# Sub Regional RTEP Committee PJM Mid-Atlantic Reliability Update

July 12, 2021

# Changes to Existing Projects

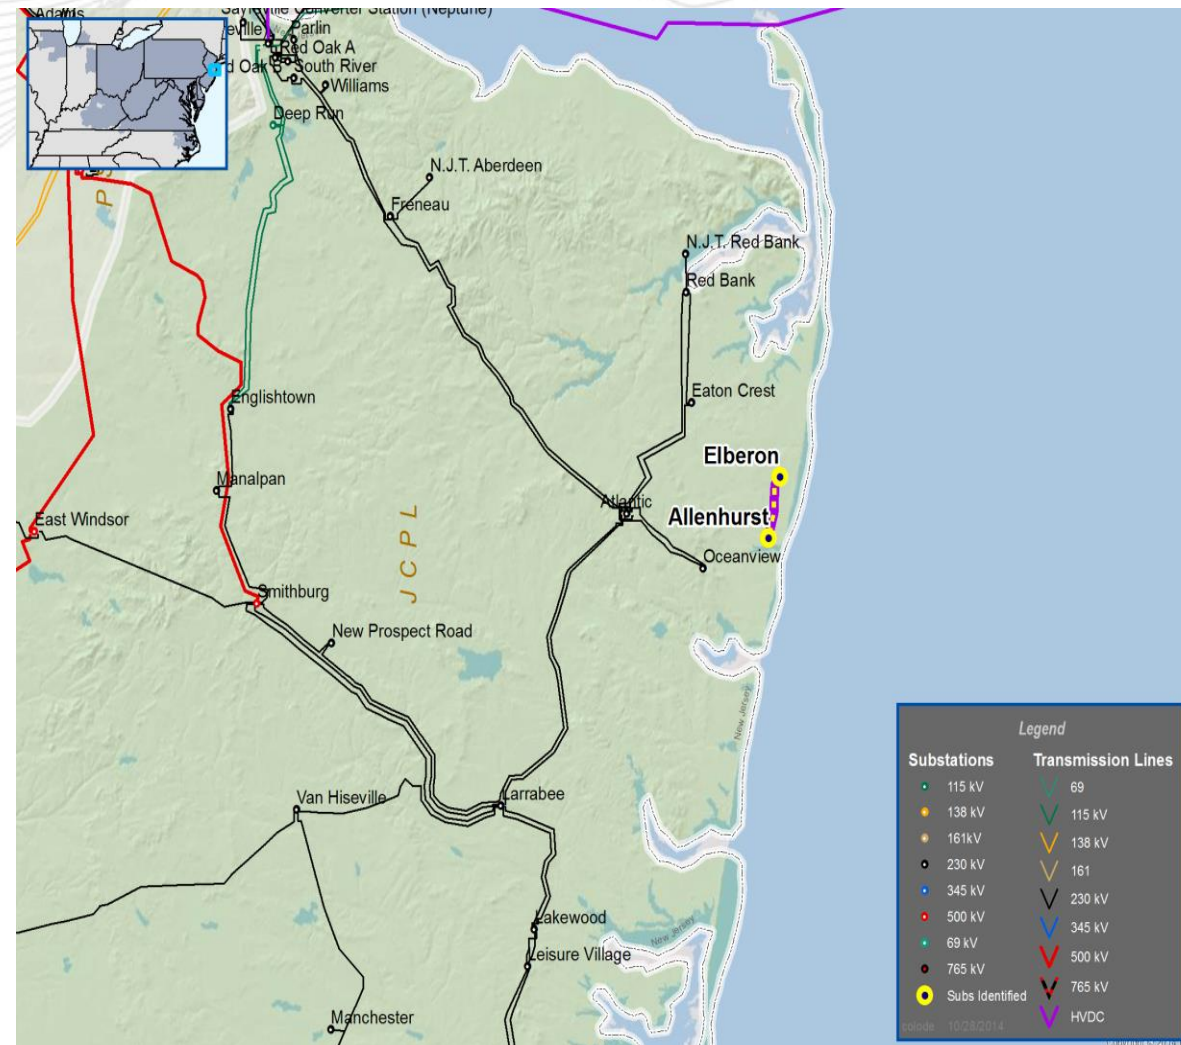
- The Allenhurst to Elberon (V74) 34.5 kV circuit is overloaded for the loss of the Bath Avenue – Long Branch (V74) 34.5 kV circuit.
- The Bath Avenue – Long Branch (V74) 34.5 kV circuit is overloaded for the loss of the Allenhurst to Elberon (V74) 34.5 kV circuit.

- Upgrade the V74 34.5 kV transmission line between Allenhurst and Elberon Substations. (2014\_2-4F)

The Allenhurst to Elberon 34.5 kV circuit will be upgraded as part of the MCRP project.

- B3130.9 Rebuild/Reconductor the Allenhurst to Elberon (2.0 Miles) 34.5 kV circuit
- The B2586 will be replaced with B3130.9 and will be canceled.
